C703: A5-543 Drive End Rectifier-Housing Assembly/ A9-984 Pulley Bushing

Replacement Instructions

Figure 1—Replacement Details

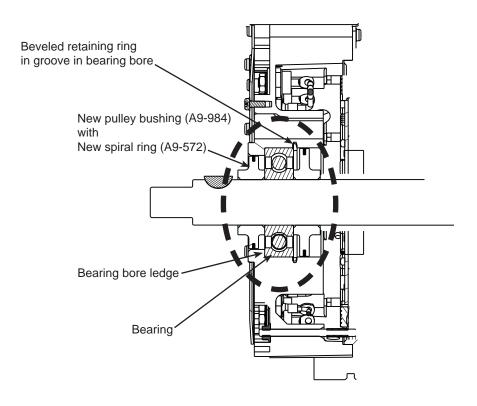
Two changes have been made to the A5-543 DE rectifier-housing assembly:

The installation of the bearing only requires the beveled retaining ring.

A smaller outer-diameter pulley bushing (A9-984) and spiral ring (A9-572) are now required in place of the existing outer DE bushing and ring. Both the new bushing and spiral ring are enclosed in an envelope with the housing.

- a. Use CEN A10–108 bearing tool placed on bearing outer race and press bearing into the DE bearing bore from the inside until it bottoms out on the ledge. See Figure 1.
- b. Install beveled retaining ring in groove. See Figure 1.
- c. Follow instructions in service manual to continue assembly.

a. Wind new spiral ring in groove around new ring carrier. Lubricate spiral ring with DuPont™ Krytox® GPL 225 or equivalent. Install ring carrier in bearing bore with short hub on carrier facing bearing. See Figure 1.
